Subject: MHI's Responses to US-APWR DCD RAI No. 212-1950

Responses to Request for Additional Information No. 212-1950,
Revision 1

**US-APWR Design Certification
Mitsubishi Heavy Industries
Docket No. 52-021**

RAI NO.: NO. 212-1950 REVISION 1
SRP SECTION: 03.07.02 – Seismic System Analysis
APPLICATION SECTION: 03.07.02
DATE OF RAI ISSUE: 02/25/09

Fig.19.3 Comparison of ISRS for NASTRAN and ANSYS FE R/B models (EW Direction)
 (Sheet 1 of 5)

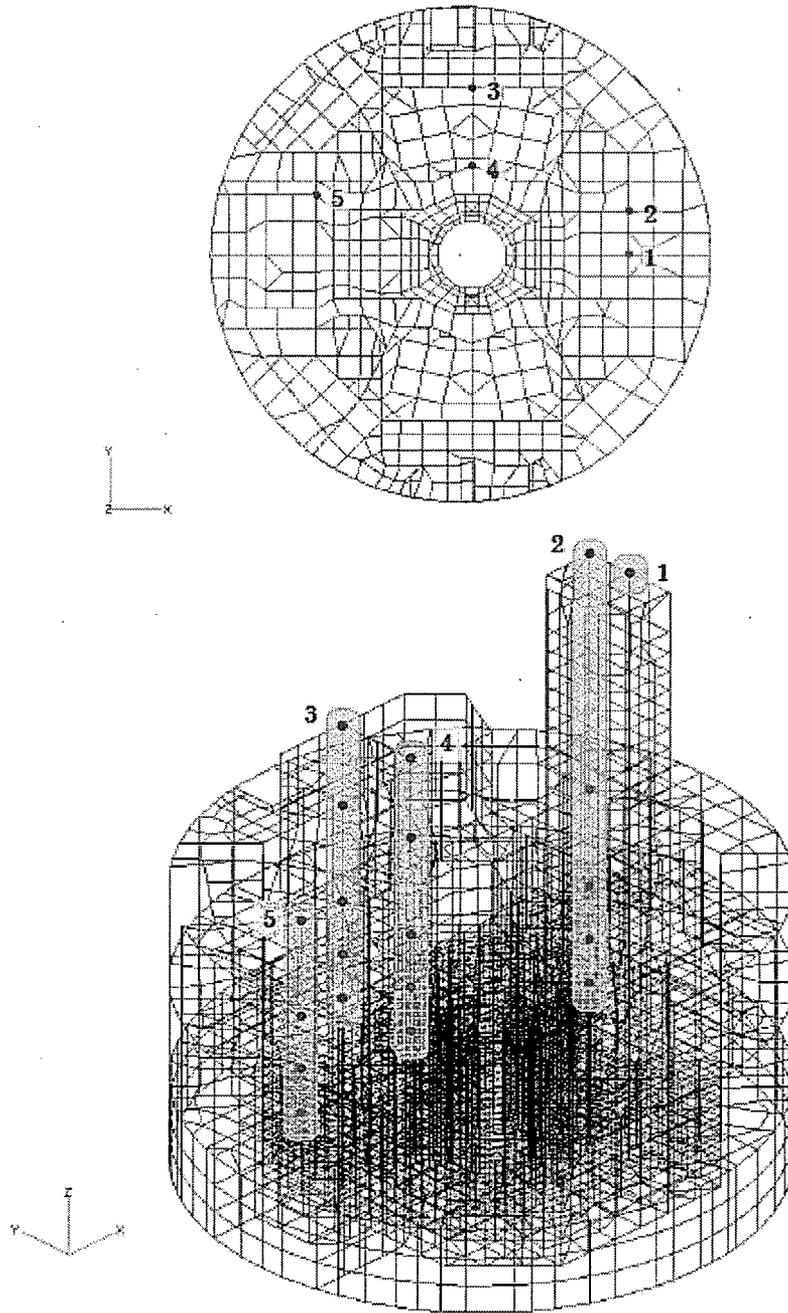
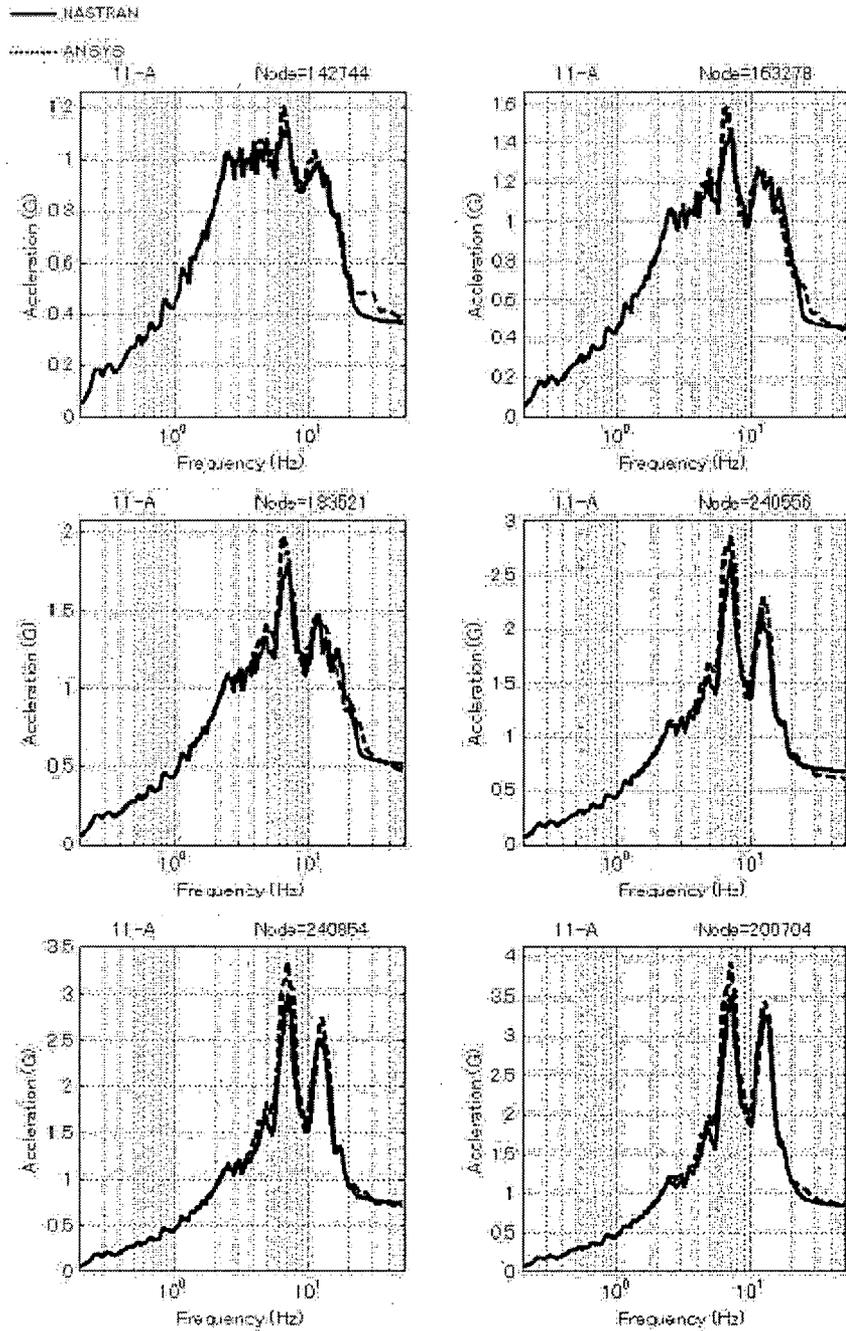
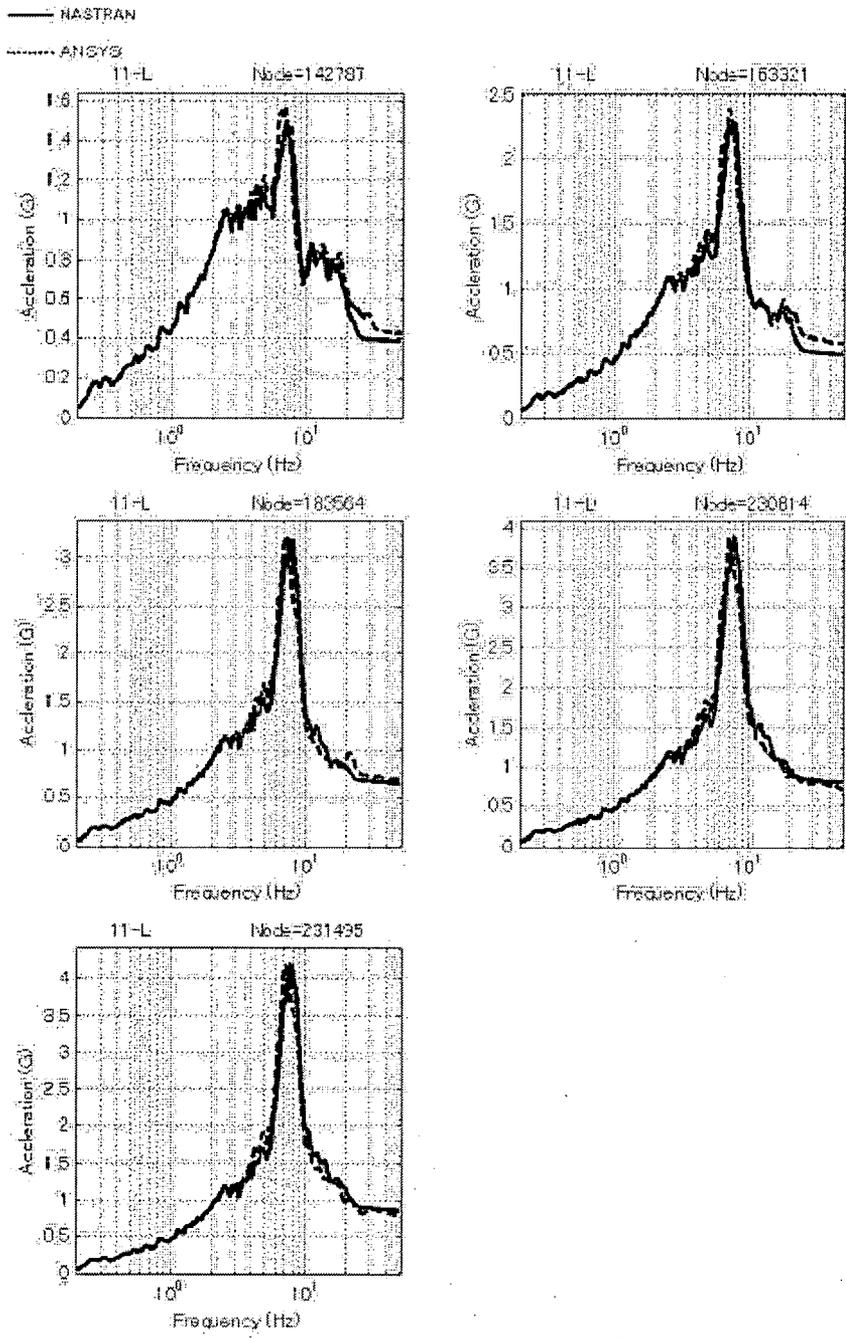
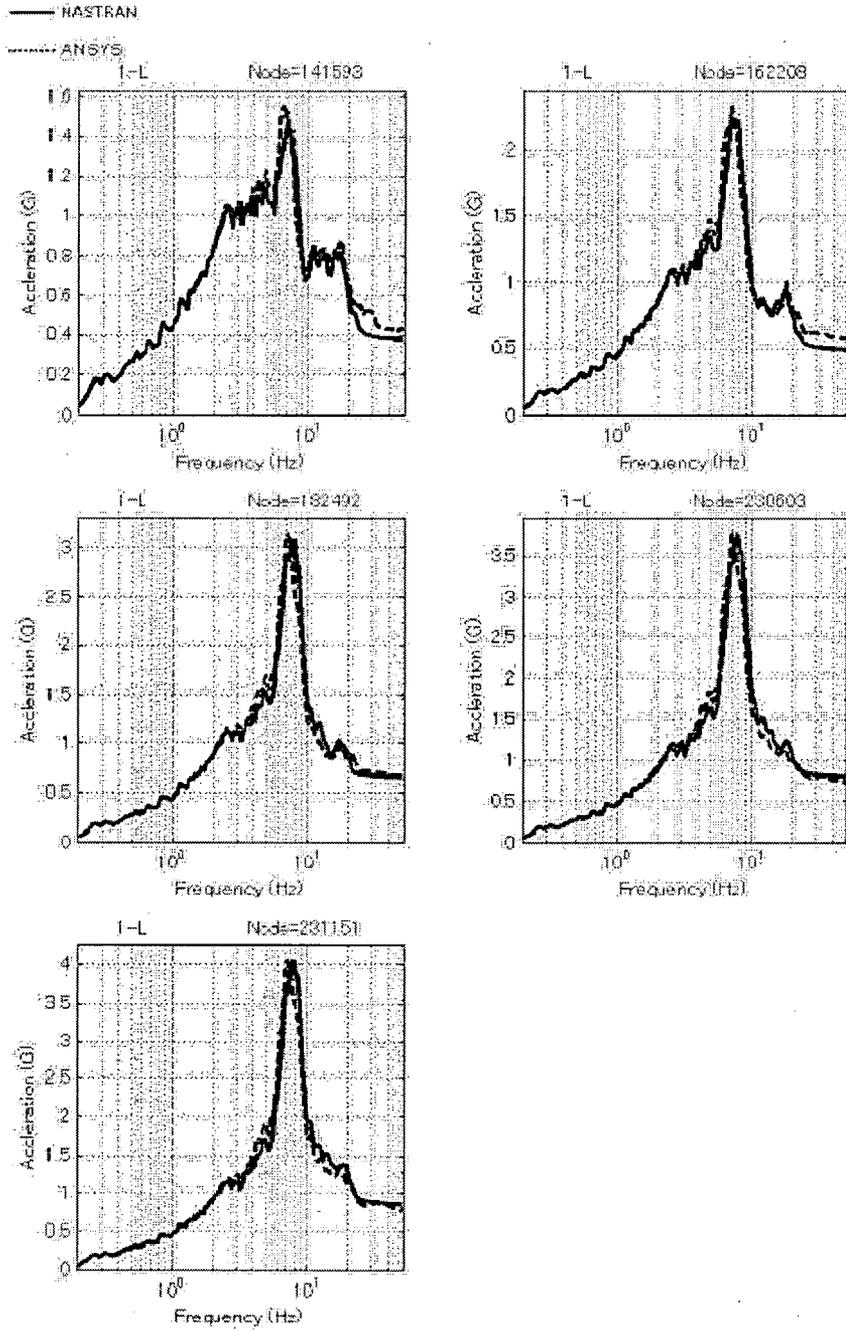
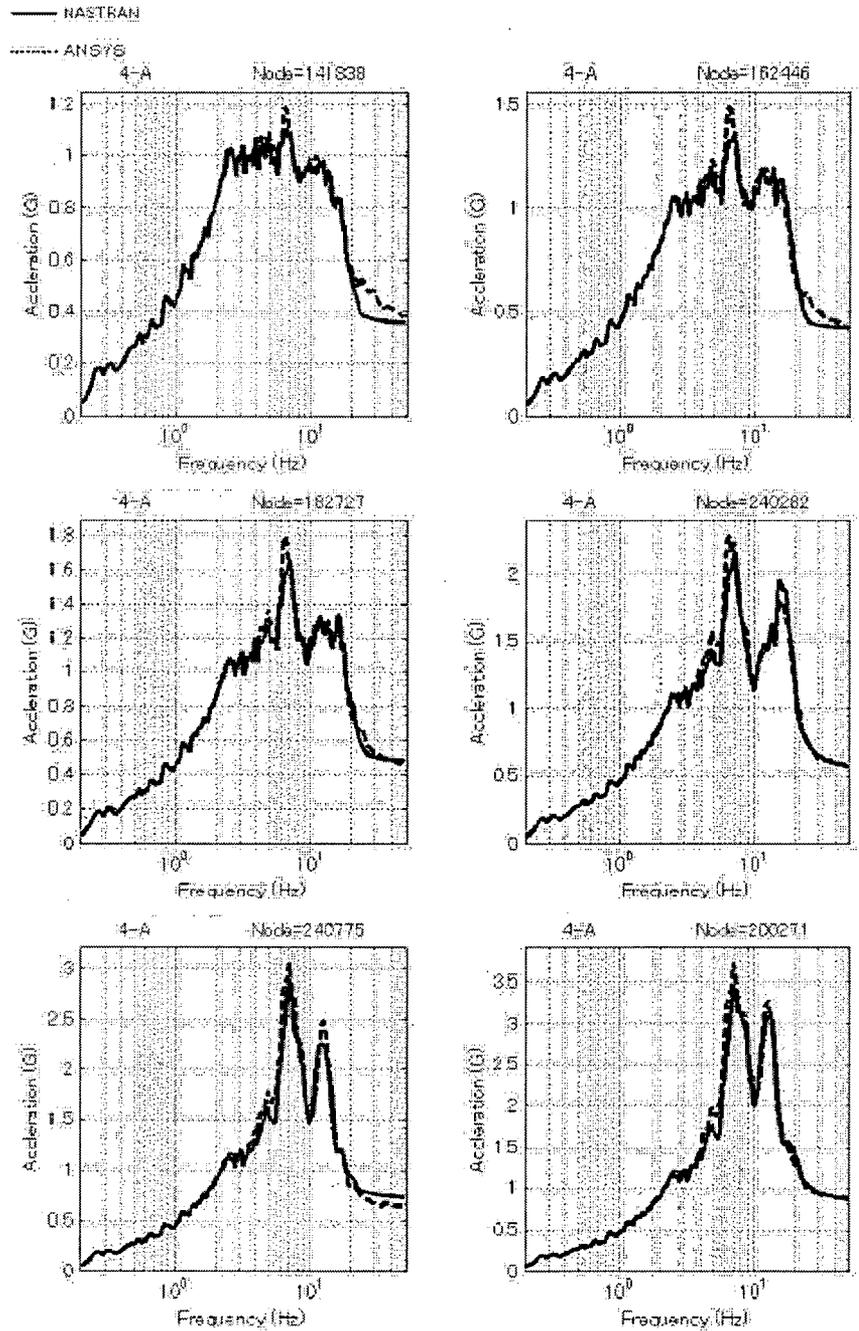
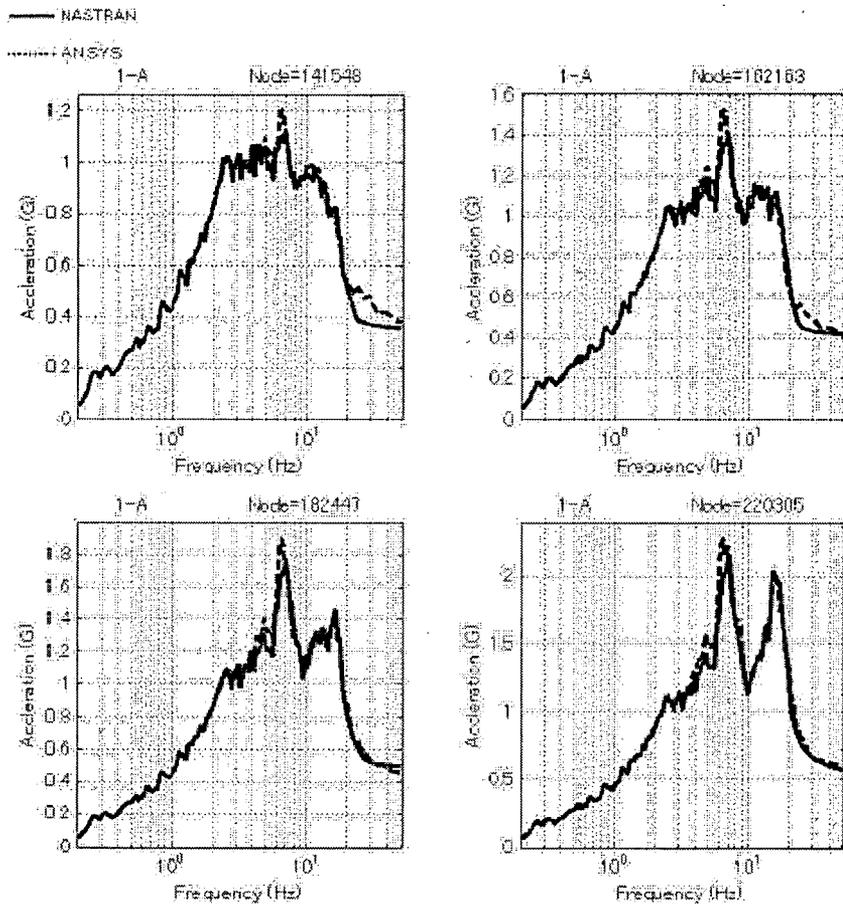
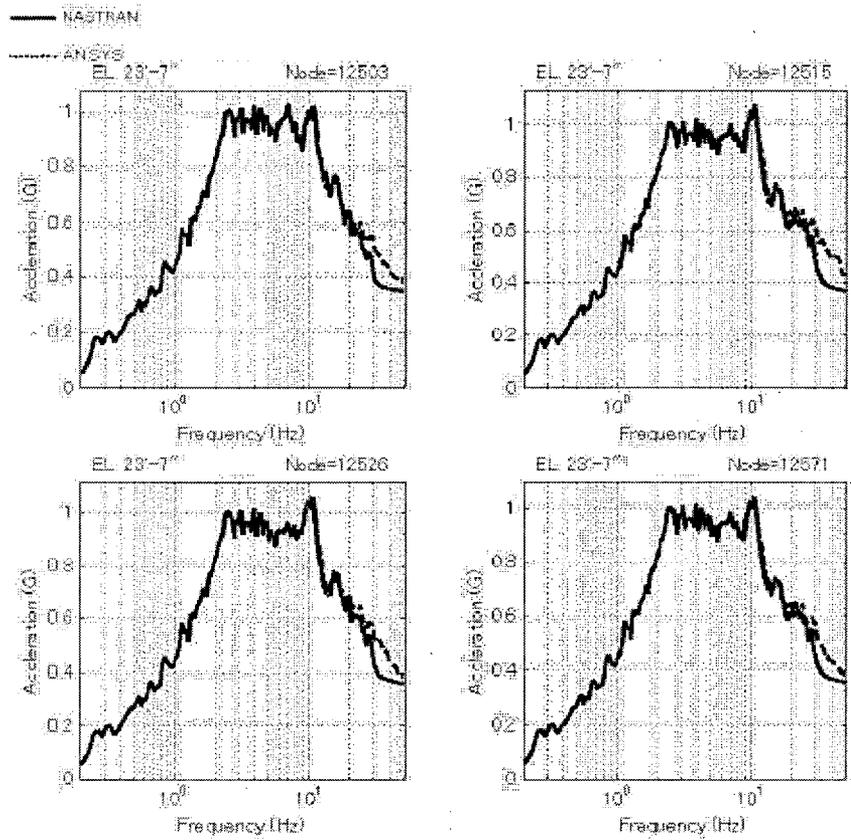
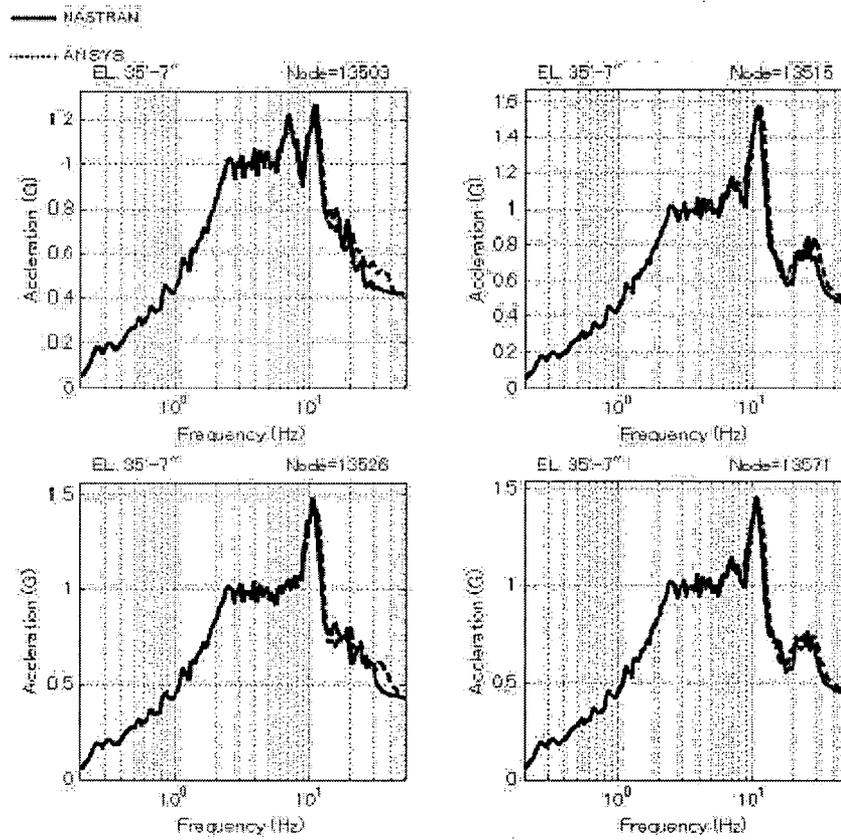
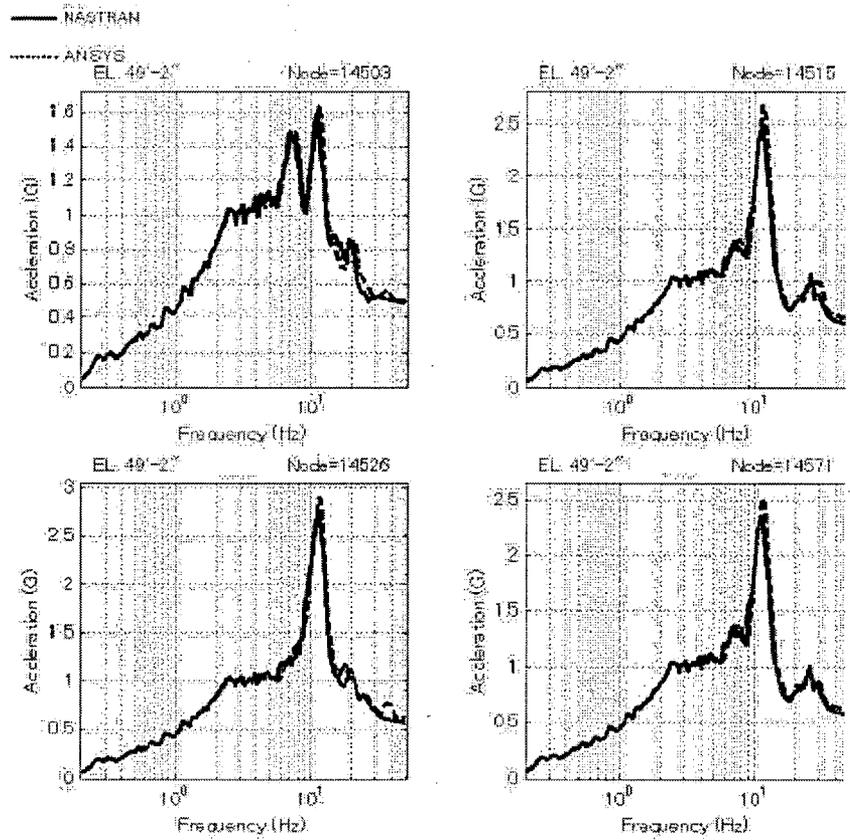
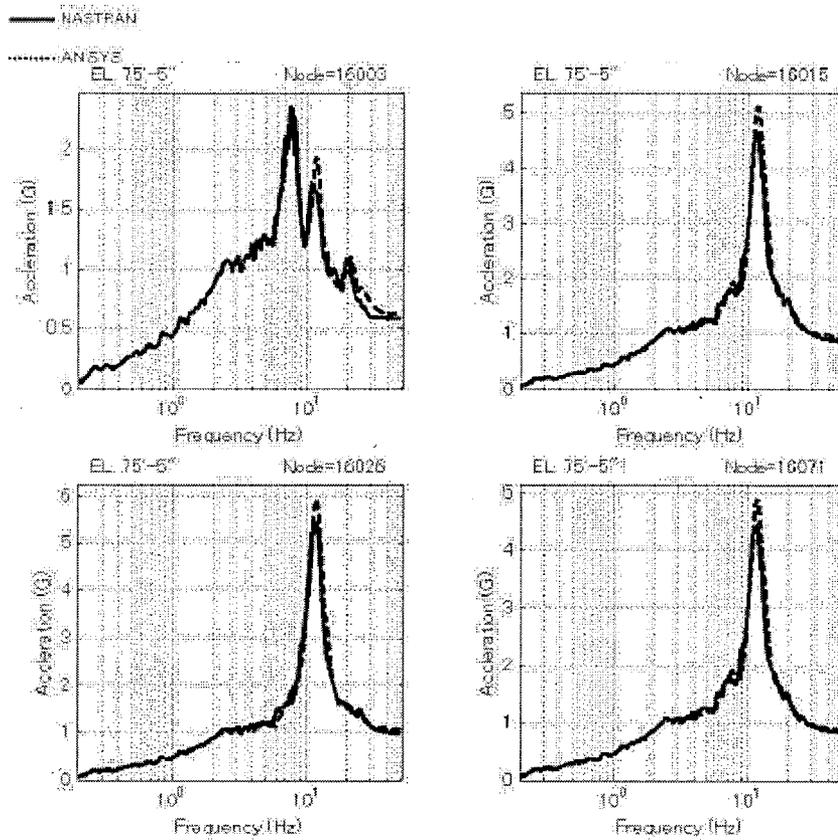
In Section 3.7.2.3.1 of the DCD it is stated that the NASTRAN finite element models are used for validation of the dynamic lumped mass stick models and the NASTRAN results are validated by comparison to the results of separate ANSYS finite element model analyses. Provide results and details of the NASTRAN and ANSYS validations. Describe how the various finite element models that were developed for validation meet the guidelines of SRP Sections 3.7.2.II.3.C.ii and iii.

To verify whether the dynamic properties of the NASTRAN FE model conform to those of the ANSYS FE model, the 5% damping ISRS are calculated at several node points in both models that represent main floor levels. The points selected for validation are shown in Figures 19.1 and 19.2 (below) and Tables 19.1 and 19.2 (below) which are the same points selected in Subsection 3.7.2.3.10 of the DCD.

As stated in the response to question RAI 3.7.2-8 of this RAI, ISRS which incorporate the effects of local vibration modes will be provided in Revision 2 of the DCD. The revision will meet the guidelines of SRP Section 3.7.2.II.3.C.iii.

Further results and details of NASTRAN and ANSYS FE model validations will be provided in Revision 2 of the DCD. The response previously submitted for RAI 212-1950, Question RAI 3.7.2-8, states the ISRS, considering local vibration modes, will be provided in Revision 2 of the DCD.
